STAFF COMMENTS

HEARING DATE: July 23, 2024

A-24:137 – 820 Rymal Road East, Hamilton

DRAWING #
3-105

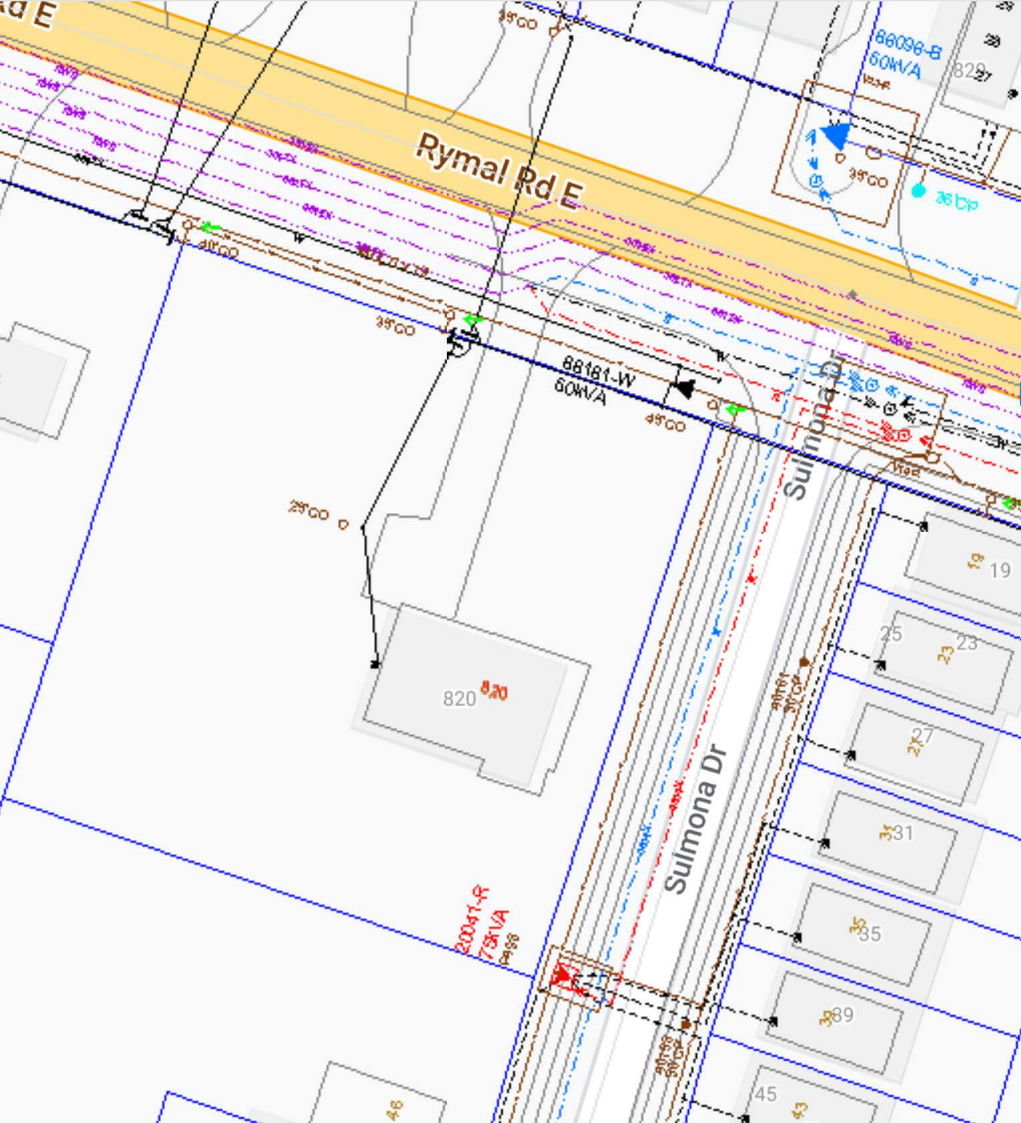
- Minimum 4m horizontal clearance from existing O/H line(s) must be maintained at all times as per Alectra Utilities Standard 3-105. Please consult with Alectra Utilities if further clarification is required.
